PROJECT
REVISED BUILDING PLANS OF GROUP HOUSING SCHEME 'THE DAHLIAS' IN ZONE-10 FALLING IN GROUP HOUSING COLONY AREA MEASURING 476 60/15 ACRES NAMELY DLF-5 (FORMERLY KNOWN AS DLF CITY PHASE-V) GURUGRAM BEING DEVELOPED BY DLF LIMITED.

BS-02

FLOOR PLAN BASEMENT-2

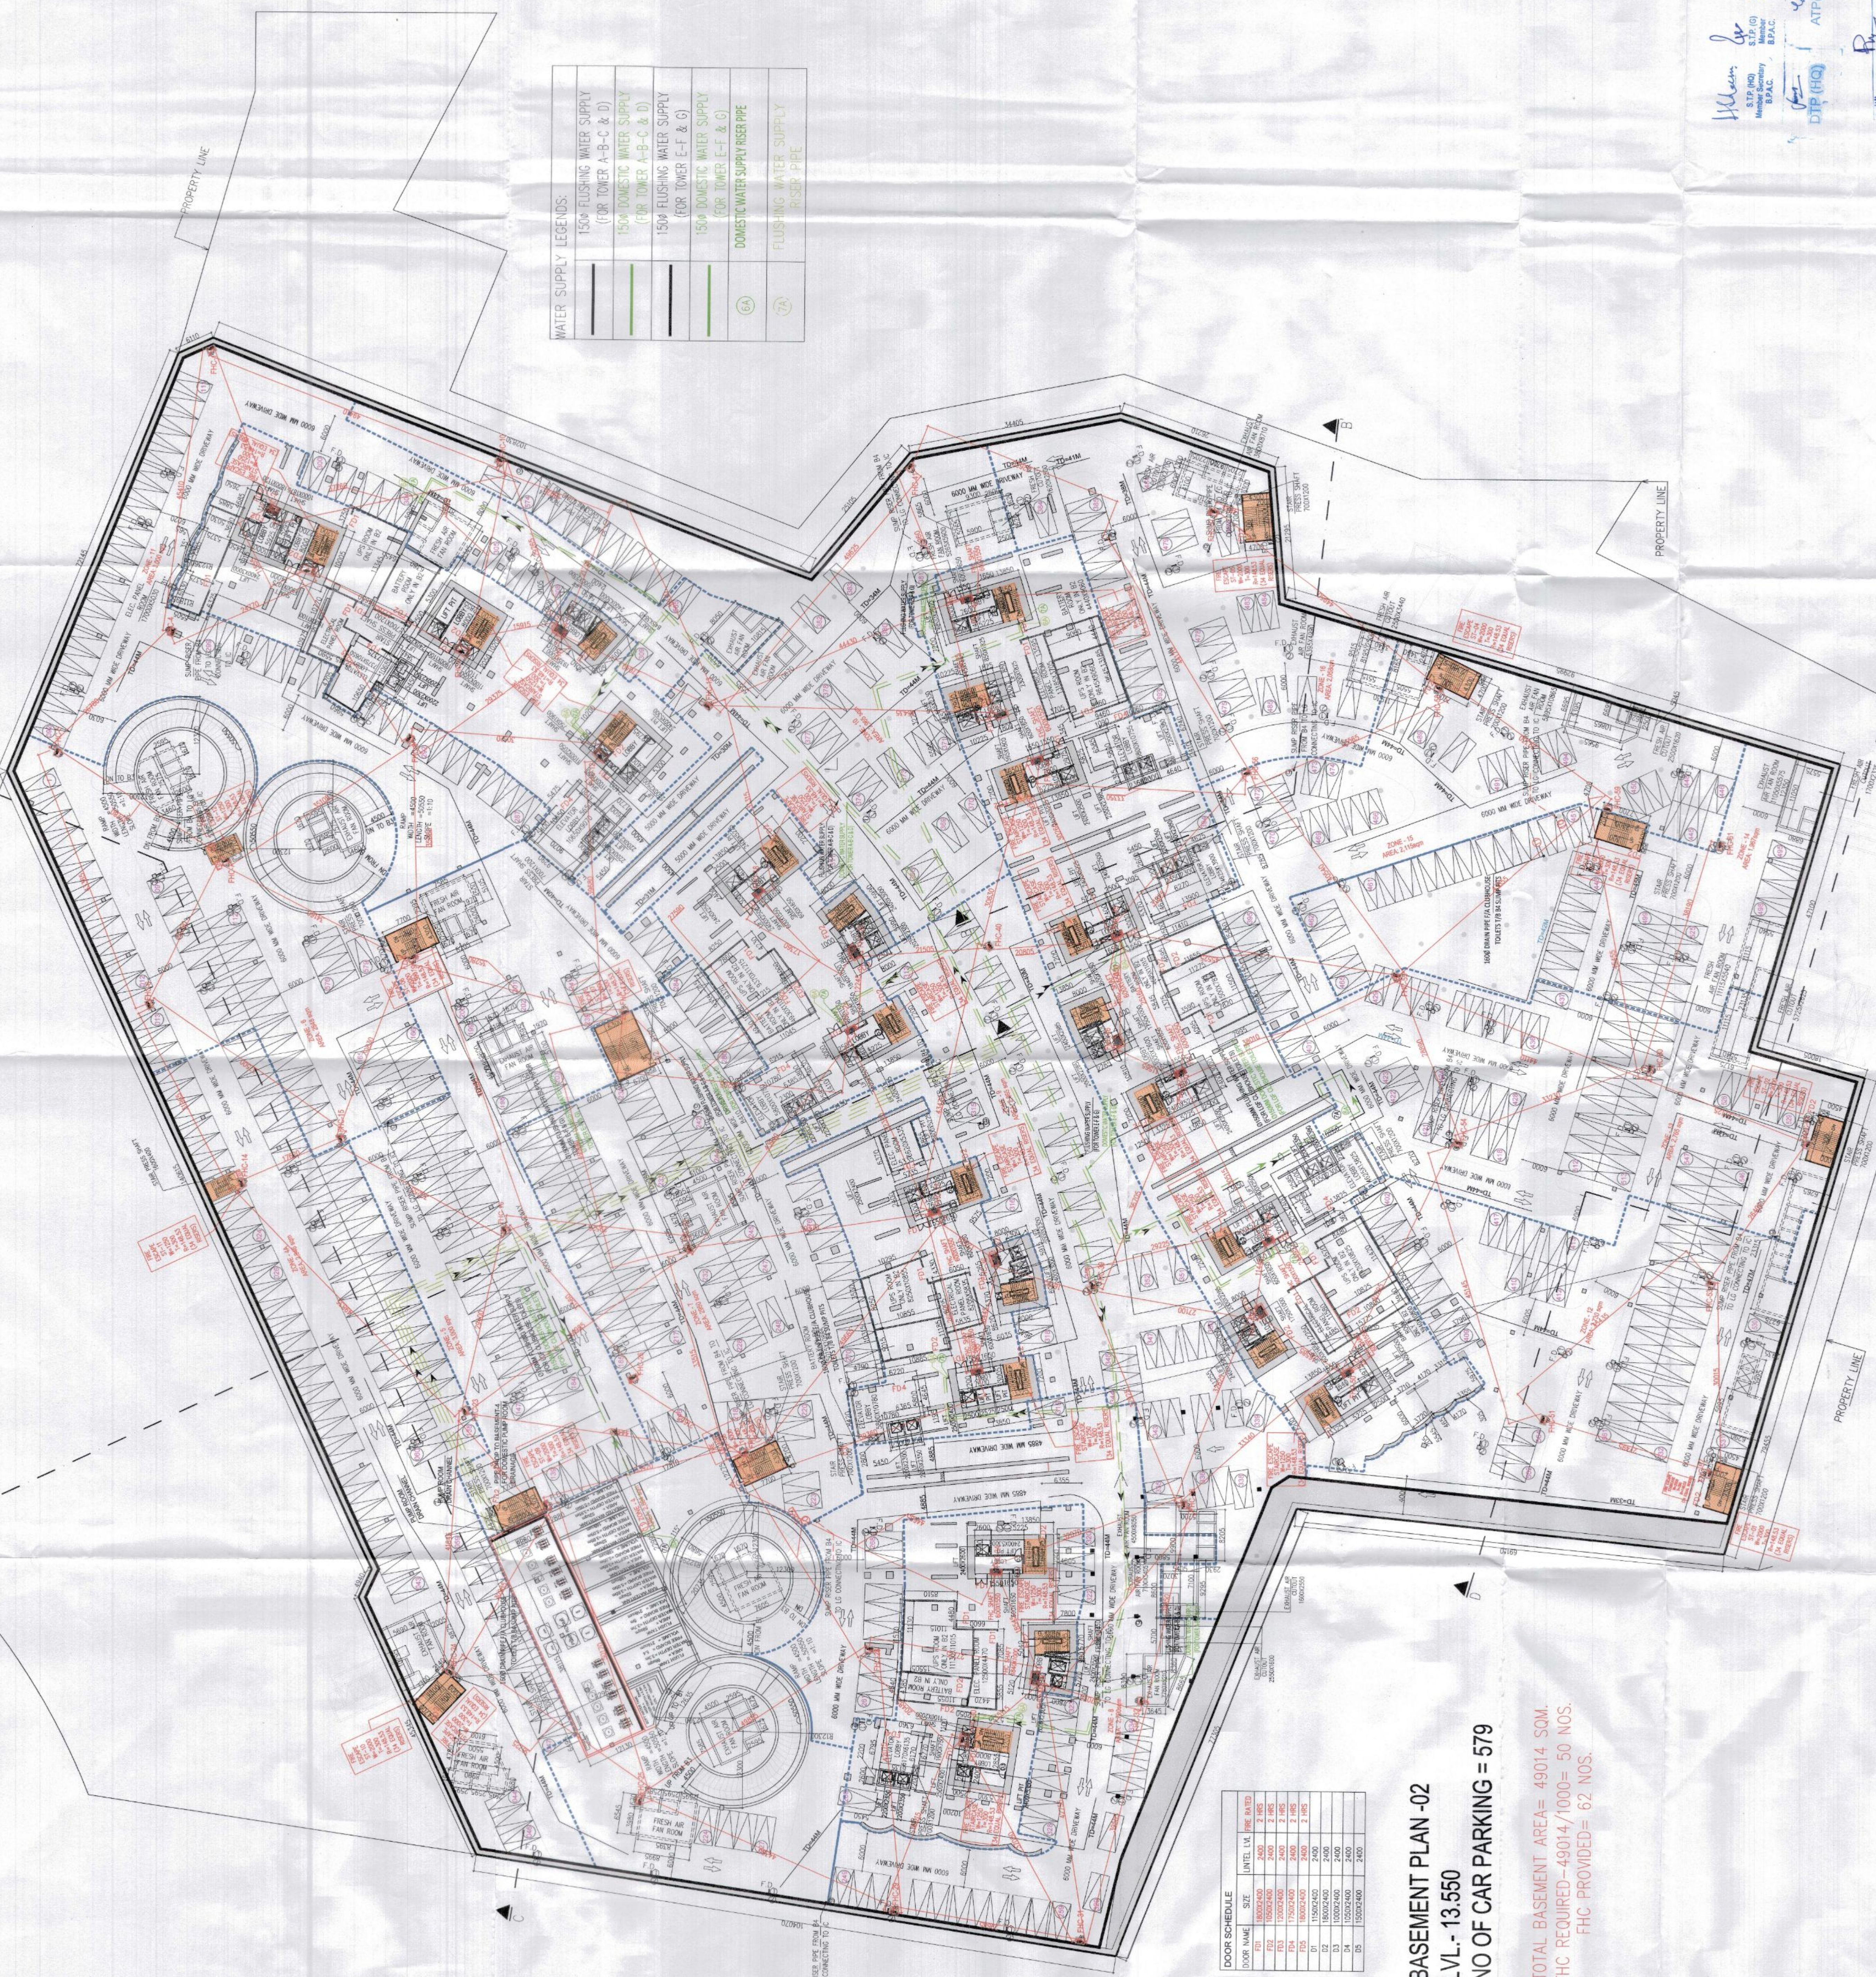
ALSO TYPICAL COMMENTS:
1. PROVIDE SHAFT FOR SEWAGE PREVENTION FROM LG-GR TYPICAL.
2. PROVIDE SHAFT FOR SEWAGE PREVENTION FROM LG-GR TYPICAL.
3. UPDATE THE ZONE AREA AS FOLLOWED
